Department of Energy
National Nuclear Security Administration
Washington, DC 20585
November 18, 2002

DNFSB ISSUES/RESPONSES (U)

Detailed Response to DNFSB Staff Issues and Observations

FIGURE 1

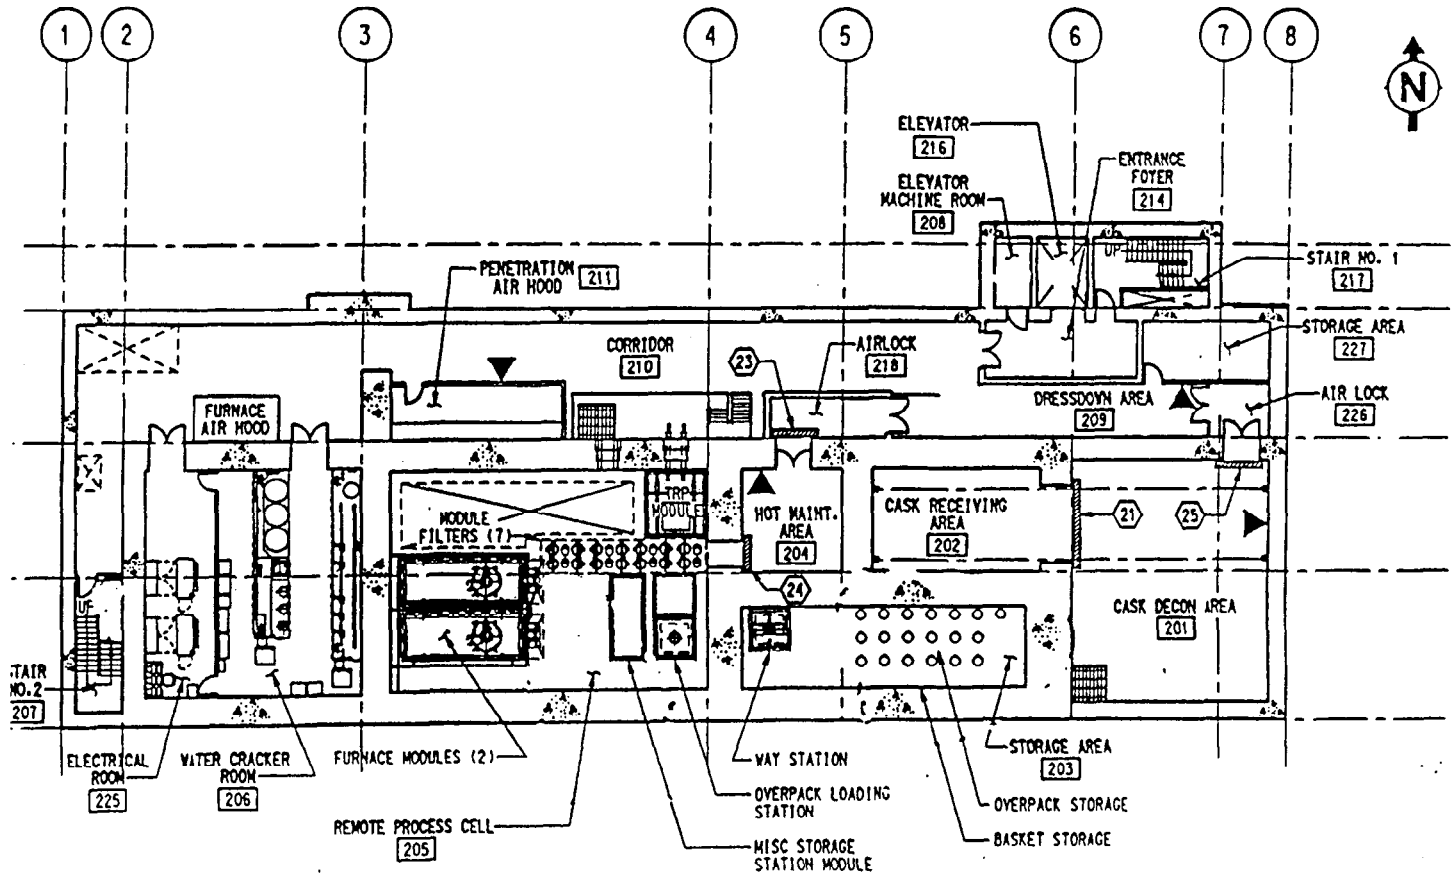
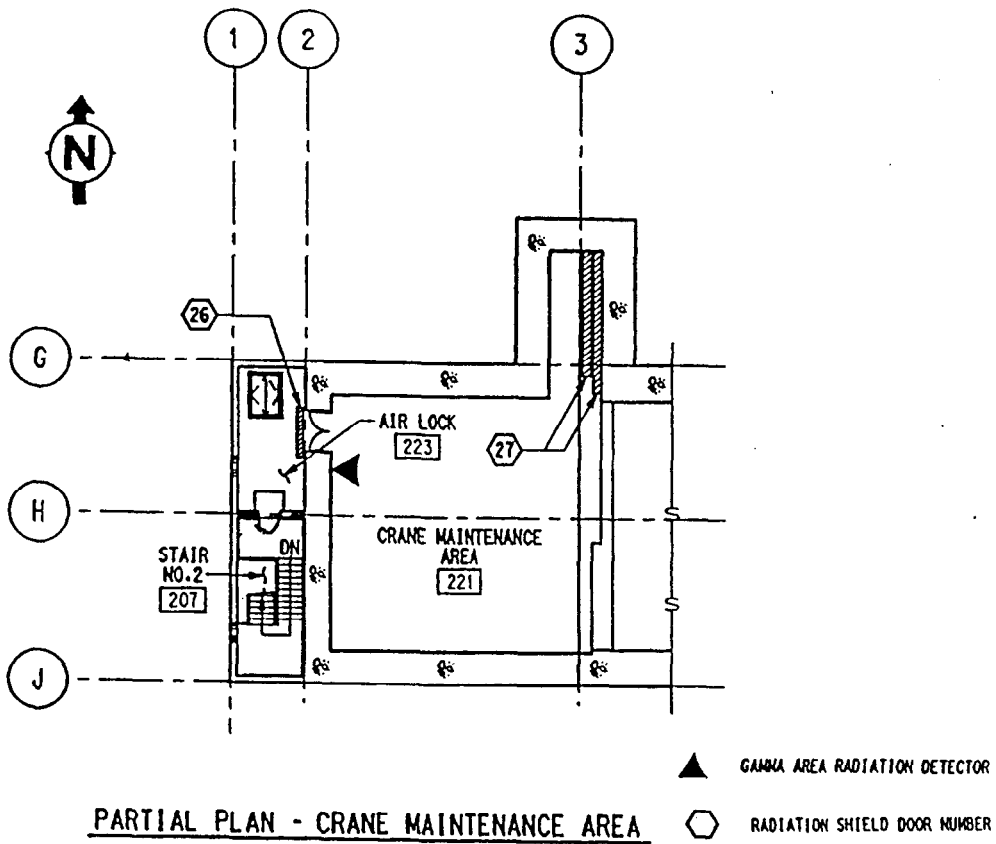
The design process hazards review identified a potential for exposure of workers to high levels of radiation if the shield doors should be inadvertently opened when cask or truck bay areas are occupied. Identification of radiation monitors and alarms to protect the workers was recommended. The control identified in the PSAR is limited to operator training and does not include implementation of any design features to protect workers.

1. RE-3, Located on the north side of the dressout area. Refer to Figure 1 and reference 3.

2. RE-5 Located on the outside of the north side of the penetration air hood room wall. Refer to Figure 1 and reference 3.
3. RE-1 Located on the east side of the truck bay. Refer to Figure 3 and reference 3.
4. RE-6 Located on the outside of the north HEPA filter room wall. Refer to Figure 3 and reference 3.
